GROWTH MANAGEMENT DEPARTMENT STAFF REPORT
SOUTH ANASTASIA OVERLAY DISTRICT
February 23, 2023 Public Meeting
SADRB 2023-01 Sandbar Deck

To: South Anastasia Design Review Board
Staff: Sloane Stephens, Planner
Date: February 14, 2023

Summary of Request: Applicant is requesting design approval for a 16' x 24' covered wood deck. This review is specifically for the architectural design of the proposed addition. The applicant has been recommended to provide physical color/material samples at the hearing to assist in Board review. Staff notes that the proposed site plan meets all setback/buffering requirements for CG zoning in the South Anastasia Overlay District, as well as impervious surface ratio and floor area ratio.

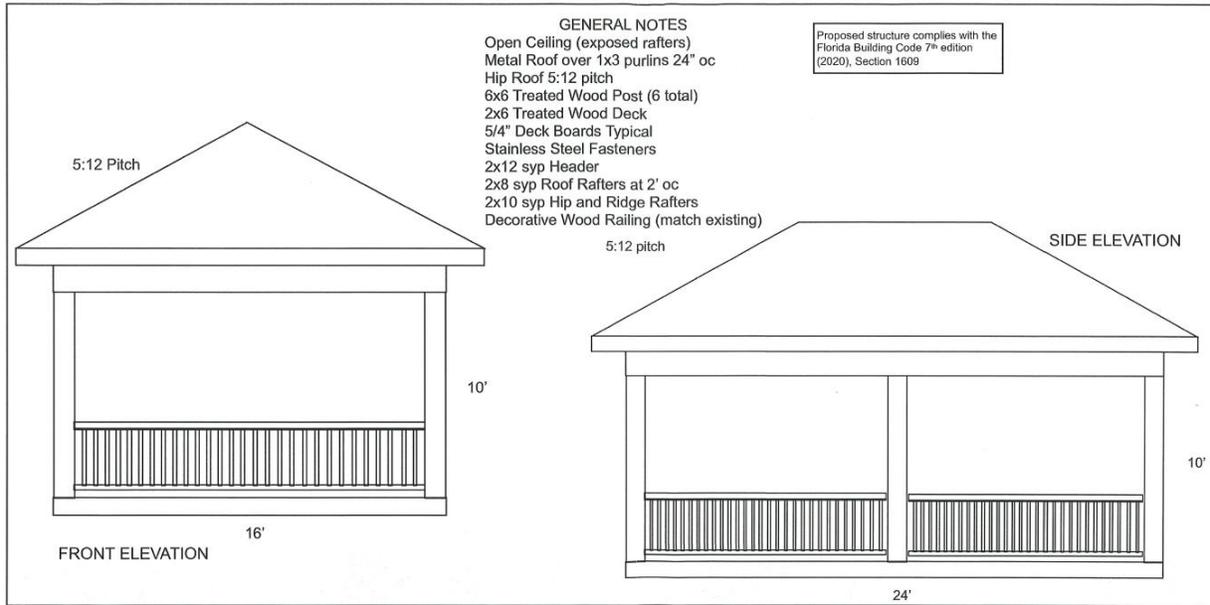
The covered wood deck is proposed to be 16' by 24'. Deck is to be located along the northern side of the building. Please see proposed site plan below showing location of deck:

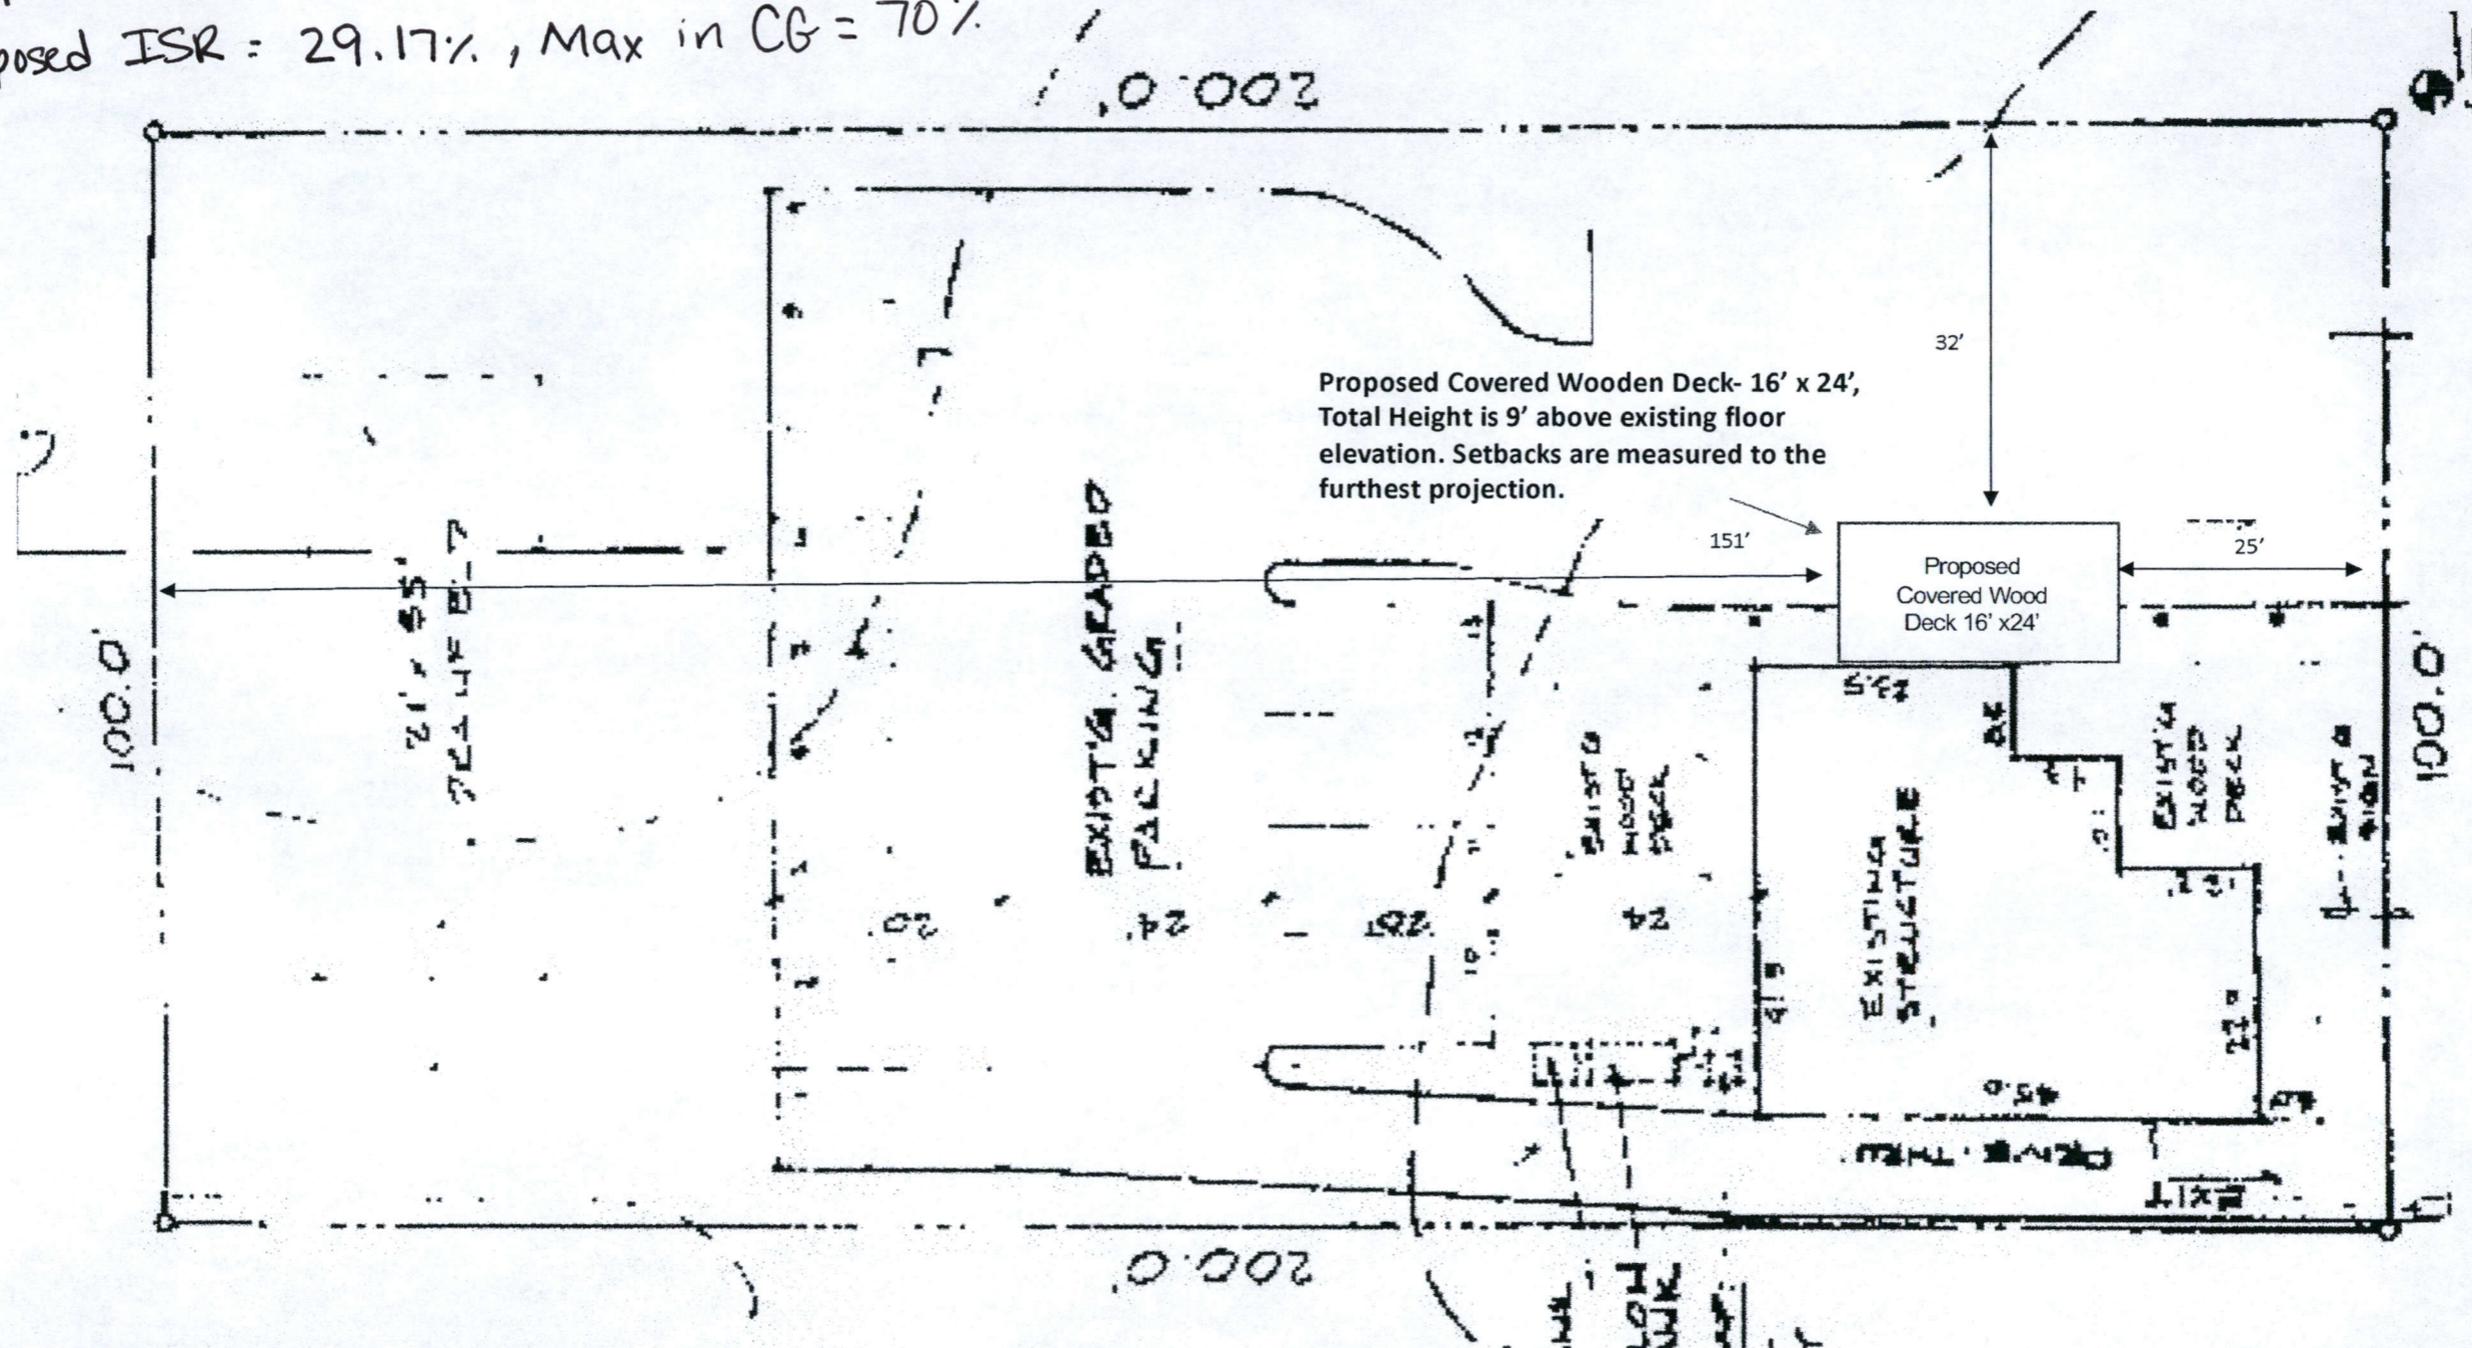
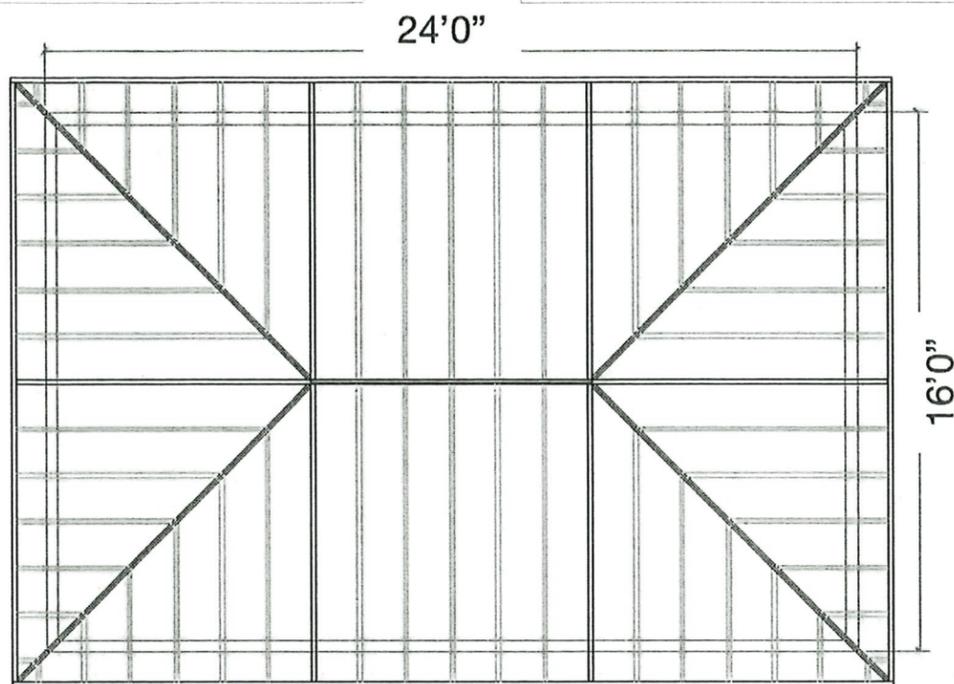
The provided elevations show that the 16' side of the deck will be facing A1A. Please see below for proposed deck elevations. Full-page elevations are provided at the end of this packet.

Additionally, the Applicant has confirmed that the colors of the deck will match the existing structure: wood frame with aluminum roofing.

Planning Division: The roof design of the proposed deck appears to be consistent with LDC Section 3.07.04.A1. In regards to roof material, LDC Section 3.07.12 states, “Roof shall consist of wood or asphalt composition shingles, barrel tile, clay tile or similar non-reflective finished material having a natural texture and appearance. Metal roofs shall only be allowed where they are characteristic of a recognized architectural style.” The proposed metal roof may be allowed if it is deemed characteristic of the “Old Florida” style. The Board may also find the proposed option more fitting as it would match the already-existing architecture. Additionally, the proposed color scheme appears to comply with the architectural design standards in the “Old Florida” style as set forth in LDC Section 3.07.11.
